DEFENSE NUCLEAR FACILITIES SAFETY BOARD

January 20, 2012

Staff Issue Report

SUBJECT: Erosion/Corrosion Wear Allowances, Waste Treatment and Immobilization Plant

Figure 1. Comparison of experimentally determined wear rate data based on depth measurements with the WTP design basis wear rate for vessels with pulse jet mixers.

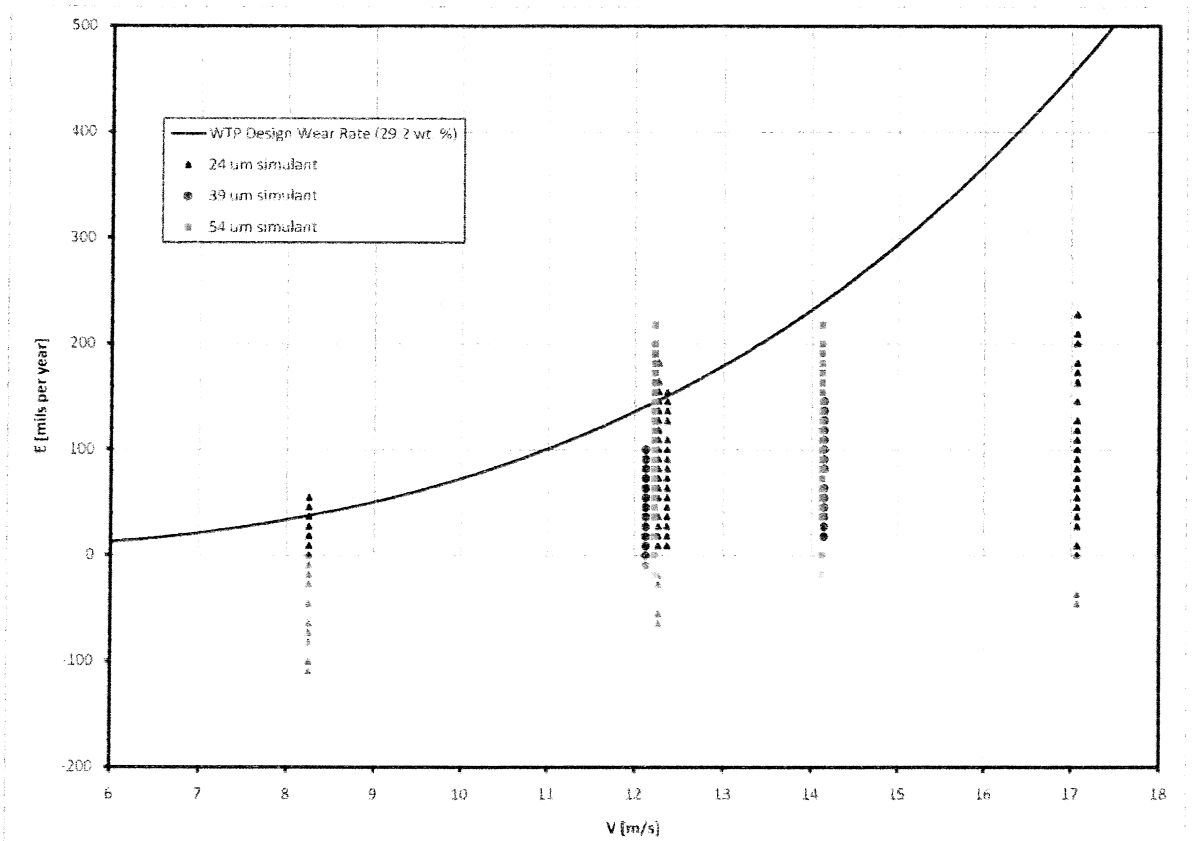
Measured Wear Is Higher Than Design Wear Rate—Figure 1 shows a subset of the data collected during the testing to close EFRT Issue M2. The plot shows the measured erosion rate (E) based on depth measurements as a function of velocity (V). Each datum on the plot represents the wear rate derived from depth measurements made at one of thirteen predetermined locations on each wear specimen. Each wear specimen was exposed to 96 hours of submerged

A substantial number of the localized wear data measurements for velocities of interest (8–12 m/s) for WTP PJM nozzles and vessel bottoms, including those obtained using the nonbounding but representative 24 μm simulant, lie above the curve that defines the design basis wear rates for WTP vessels and piping. Some of the measured data are 30 percent above the design basis wear rate. Consequently, the relationship used to define design wear rates for the vessels and PJMs does not provide sufficient conservatism.

Test Duration and Measurement Methods Cause Substantial Uncertainty—The short-duration used for the above testing (96 hours) did not cause enough wear to permit accurate measurement of localized wear. In many cases, the resulting wear was close to or less than the accuracy of the instrument used to measure the wear. The result was unreliable measurements and, as shown in Figure 1, large data scatter. The staff analyzed the data and found that the mean difference between independent measurements performed by two different analysts was 0.23 mils with a standard deviation of 0.18 mils (which corresponds to a mean difference and standard deviation of 21.1 and 16.4 in mils per year [mpy], respectively). This error is substantial considering that, as shown in Figure 1, the expected wear for 8 m/s flow is 40 mpy.

As a further indication of uncertainty, data collected at a flow rate of 8 m/s displayed a scatter over a range of -115 mpy to +55 mpy. Data collected at 12 m/s scatter over a range of -65 mpy to +220 mpy. There is no discernable pattern or trend in the data. The experimental data that suggests a negative wear rate (gray region in Figure 1) are physically unrealistic (i.e., indicate that the wear coupons were increasing in thickness during testing).
